# CITY OF ALBUQUERQUE

RE: **Lot 5 Block 41 Unit 2 Knolls of Paradise Hills  
9917 Cardinal St.  
Grading and Drainage Plan  
Engineers Stamp Date 12/3/2021 (B13D033)  
Pad Certification Date 9/20/2021**

## DRAINAGE AND TRANSPORTATION INFORMATION SHEET (REV 6/2018)

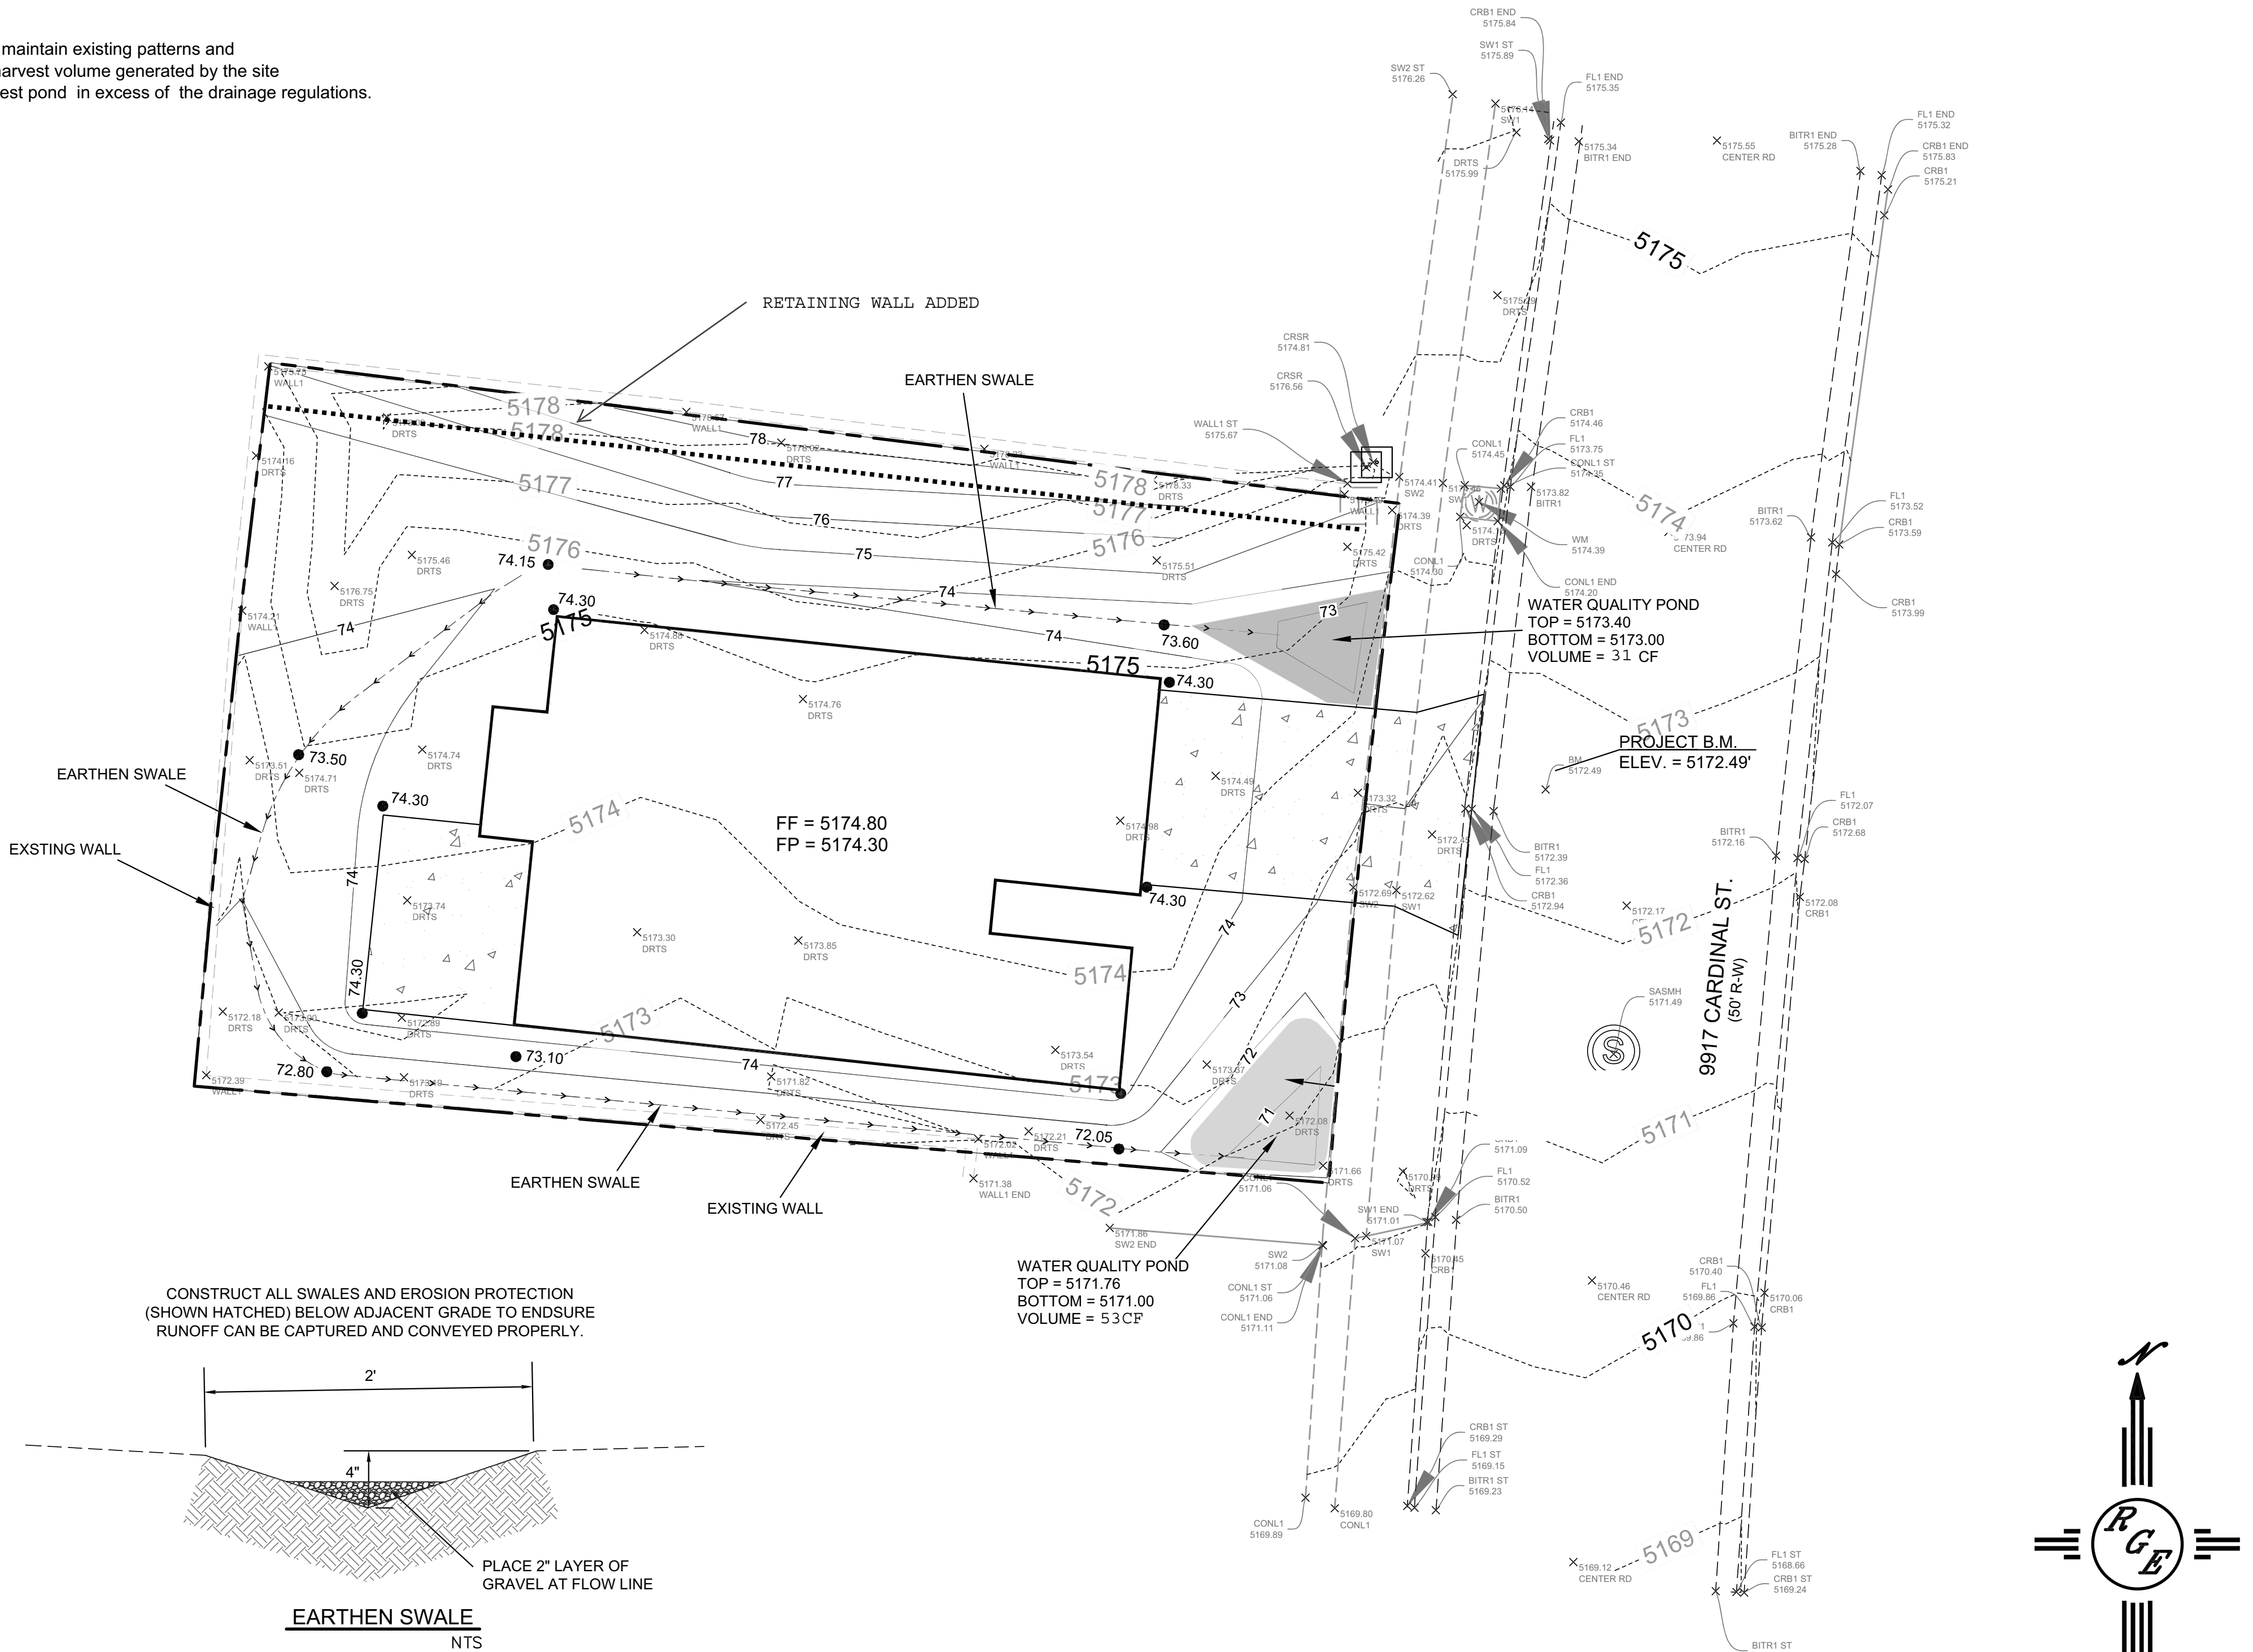
Based upon the information provided in your submittal received 12/3/2021, this plan is approved for Building Permit.

**Reiterate to the Owner/Contractor that a separate permit for a garden/retaining wall must be obtained, with the approved G&D plan. Also, advise the owner/contractor not to use dirt as a ramp to climb the curb. If dirt is used it will cause a delay in permitting.**

Prior to Certificate of Occupancy release, Engineer Certification per the DPM checklist of this plan will be required.
